SERVICE BULLETIN

BULLETIN NO: 19-006

TITLE: Safe Turn Alert Part Number Change

PRODUCT SERIES / MODEL: PT-0080 Safe Turn Alert

FIGURE 1
PT-0080 SAFE TURN ALERT

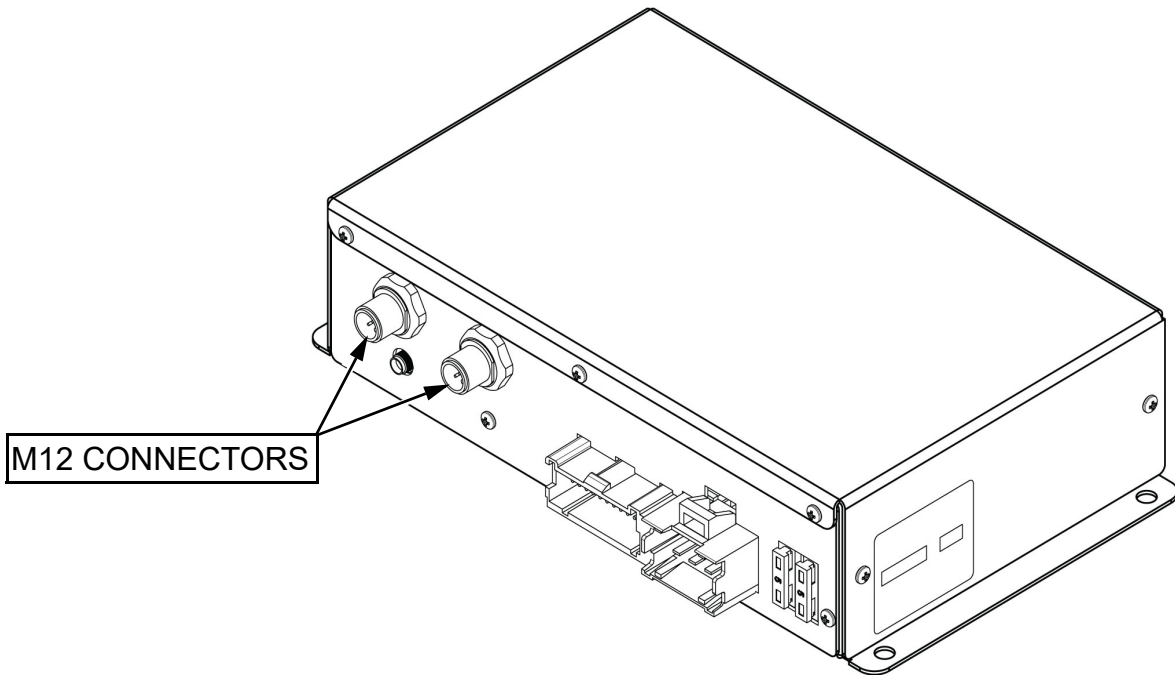
1. Protran Technology has changed the part number of the Safe Turn Alert (STA) unit. For future or replacement orders, use the new part number: PT-0080.
2. The new model PT-0080 has two M12 connectors on the back of the unit for Blind Spot Awareness feature as shown in the Figure 1.

ACTION: For all new orders of the Safe Turn Alert units, use part number PT-0080.
